REQUEST

Current Zoning: MUDD-O (mixed use development, optional)
Proposed Zoning: MUDD-O SPA (mixed use development, optional, site plan amendment)

The petition proposes development of an office building with retail uses on the vacant parcel of land, west of Capitol Towers in the SouthPark area.

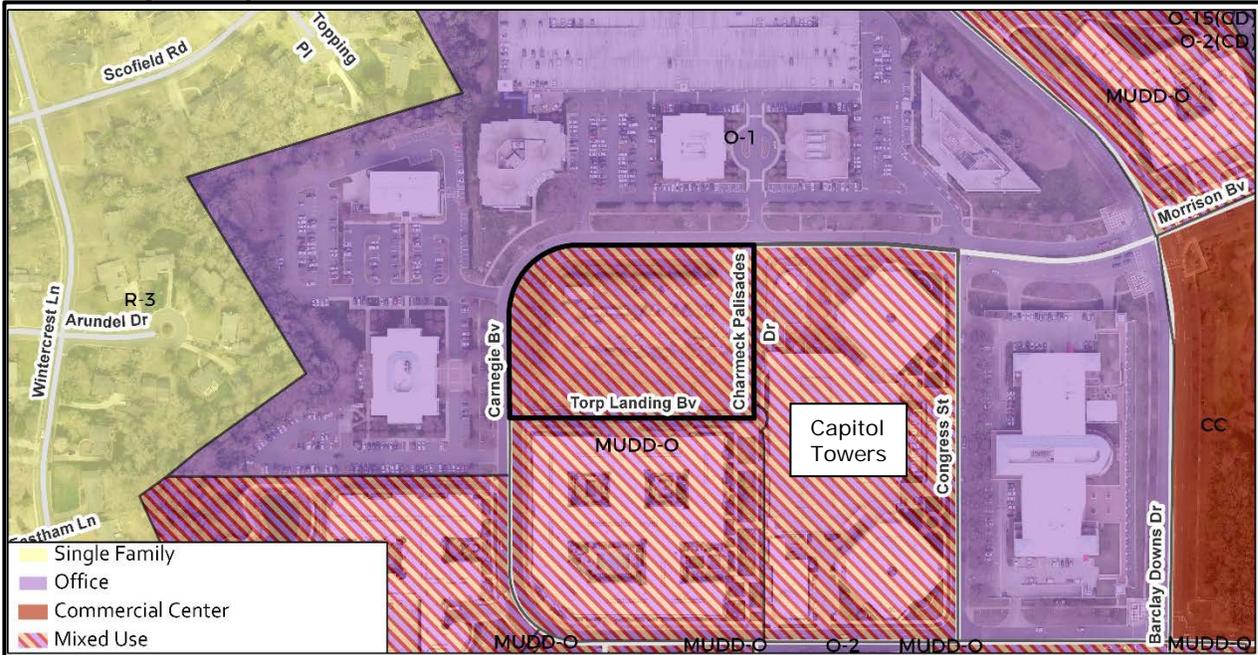
1. Amend the building perspective views to annotate key architectural design elements committed to as part of the rezoning.

2. Update the site plan and conditional notes to show an eight-foot planting strip and six-foot sidewalk along Torp Landing Boulevard to mirror the current existing opposite side of the road.
3. Amend the site plan and notes to clarify the commitment to construct the cultural loop along Charneck Palisades Drive.
4. Remove conditional note V.c. until CDOT and developer work out the agreement of what improvements can be substituted for contributions and agree on a contribution.
5. Revise the site plan to show a two-foot easement behind sidewalk outside of the right-of-way along Carnegie Boulevard.

6. Add a note to the Carnegie Street Elevation and the third Perspective View graphics to clarify the intent of the graphics is to show relationship to existing surrounding development.
-
